Public Service Electric and Gas Company 80 Park Place Newark, N.J. 07101 Phone 201/430-7000

RESPONSE TO REQUESTS FOR
ADDITIONAL INFORMATION
NO. 2 UNIT
SALEM NUCLEAR GENERATING STATION
DOCKET NO. 50-311

Public Service Electric and Gas Company hereby transmits sixty (60) copies of its responses to certain of your requests for additional information to NRC Questions 4.38, 5.96, 5.110, 13.9 (preoperational testing), Quality Assurance and Sub-compartment Analysis. The information contained herein will be incorporated into the Salem FSAR in an amendment to our application.

TYPE "G" FRAMING

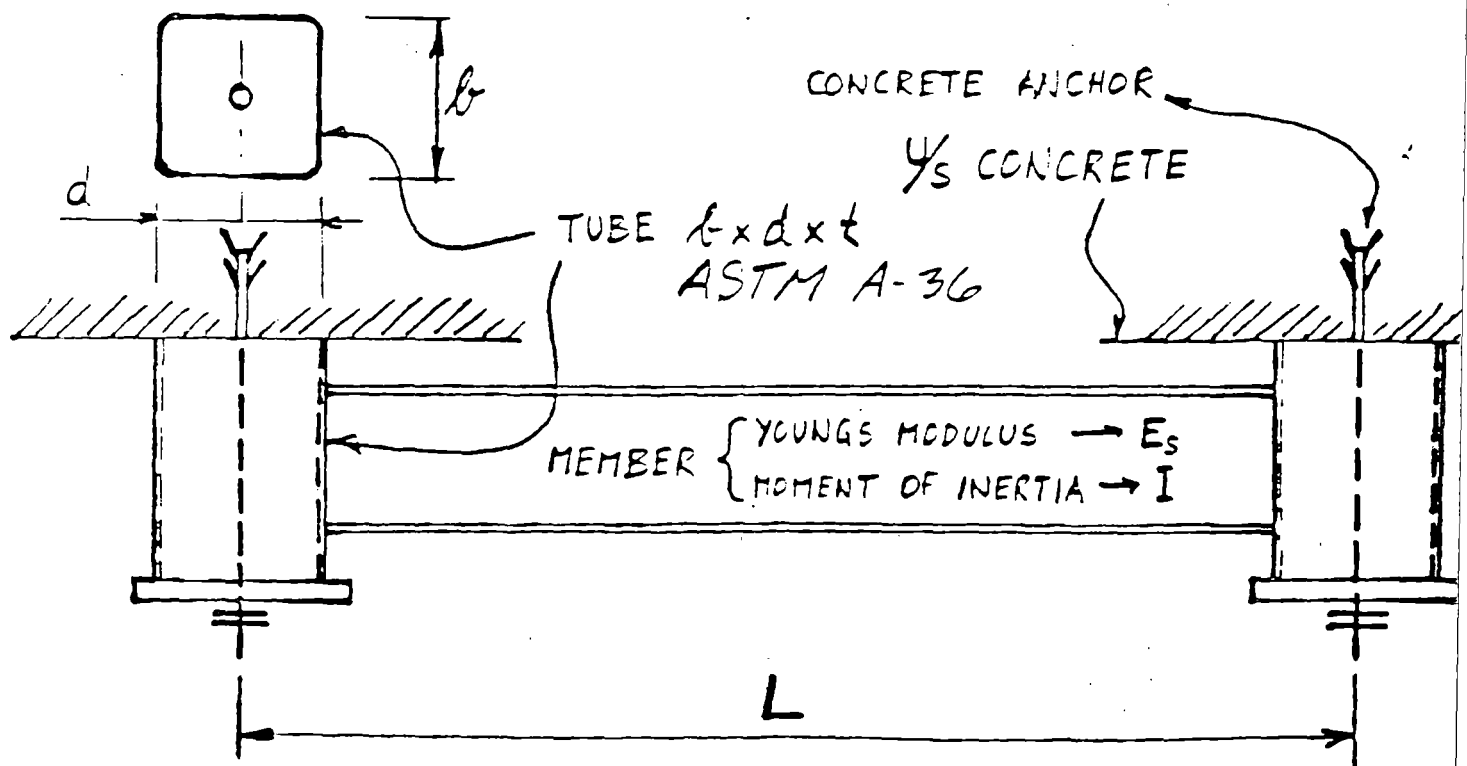
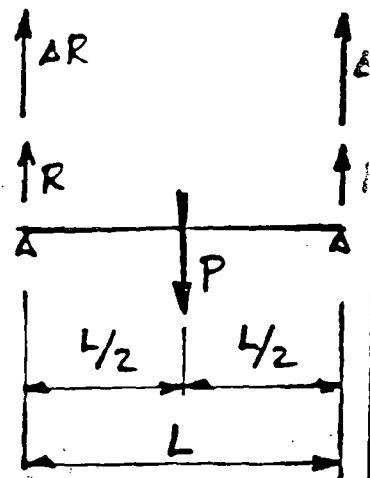
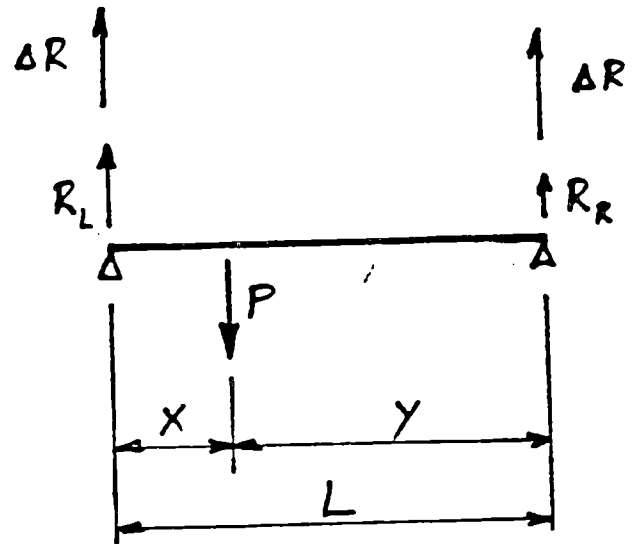
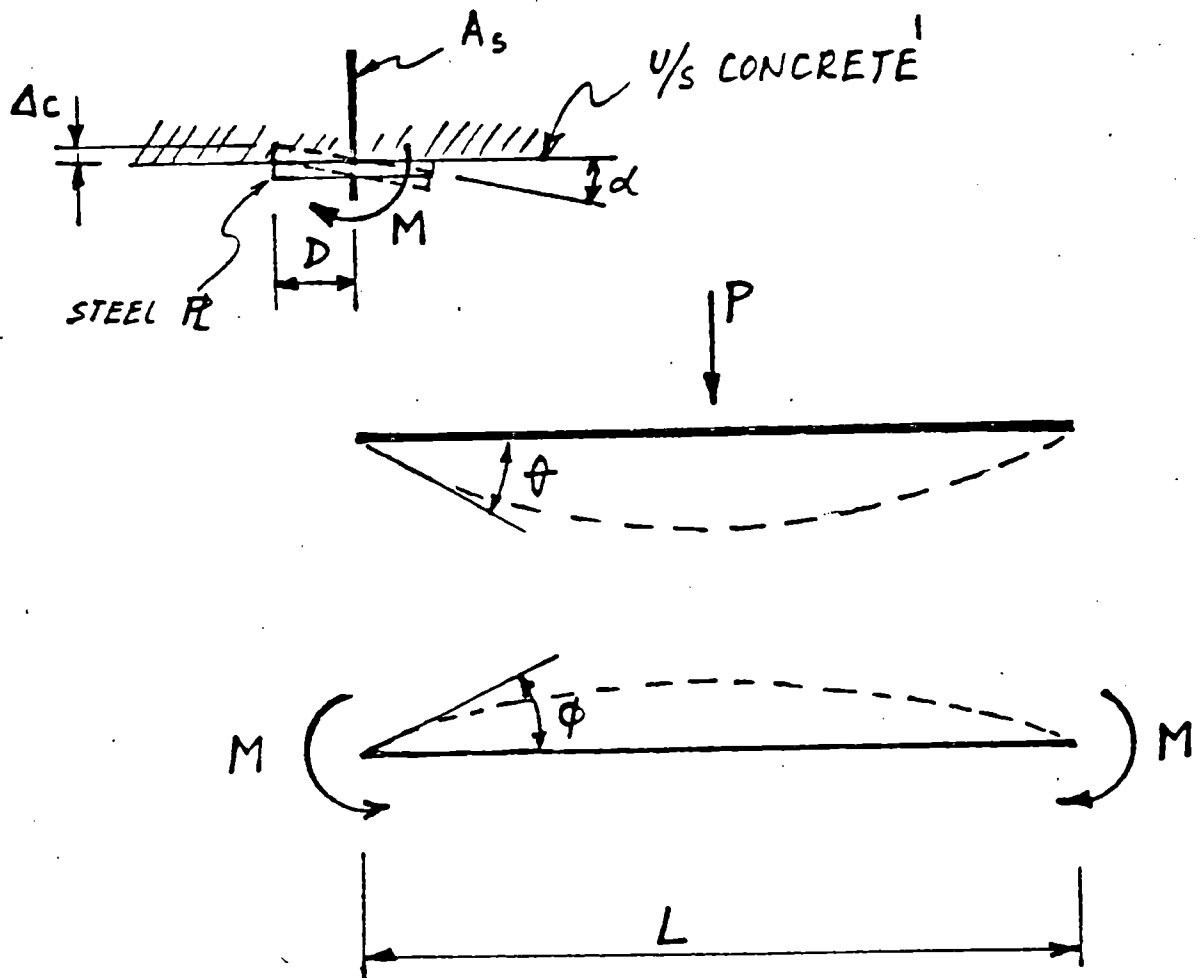
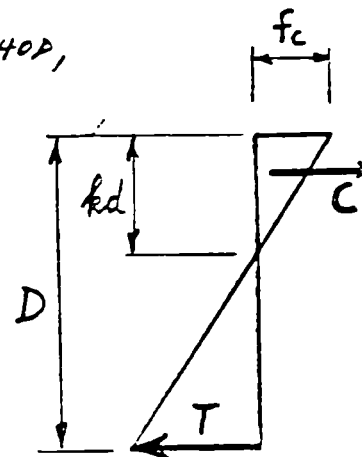
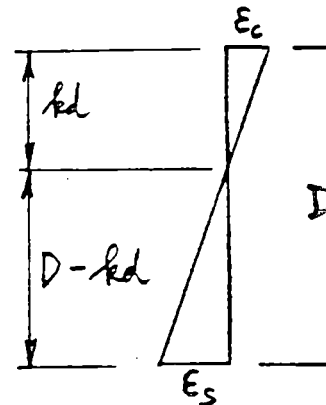
QUESTION 4.38

Appendix XVII-2461 of the ASME Code Section III requires that bolt loads in bolted connections for linear component supports include prying effects due to the flexibility of the connection.

- (1) Provide confirmation that the loads in bolted connections for linear component supports were determined by considering the deformation of the connection and tension-shear interaction for the bolts. For connections of supports which are anchored to a concrete structures provide in addition:

- a. The type of anchor bolt
- b. The factors of safety (and their bases) against pullout under static, repeated and transient loading.

This information should include representatives diagrams of the connections, material properties and interaction diagrams, the analytical techniques and models used, and the maximum stresses in the bolts and the connections under both static, repeated, and transient type loading.

- (2) If any connection was assumed to be rigid, provide complete analytical or experimental justification for this assumption.

- (1) In developing designs for bolted component supports for piping, tension and shear interactions were considered. The design conservatism on structural members is considered sufficient such that deformation of the connection does not adversely affect the capacity of connections to withstand design loadings.

- a. Types of anchor bolts used for the various bolted connections in the plant are as follows:

- (1) The majority of safety related supports employ connections bolted to concrete inserts which derive their strength from an integral steel

coil embedded in the concrete at the time of structure forming.

- (2) The other type of anchor bolt used employs an expandable wedge piece inserted in a pre-bored hole in the concrete.

b. Loads applied to these anchor bolts are within manufacturer's specified limits. Attached you will find representative analysis of typical standard supports.

- (2) The assumption of rigidity for bolted linear support connections, where applicable, is made on the basis that the applied loads to the supports have been determined by analytical methods to be adequate. Refer to attached typical support evaluation.
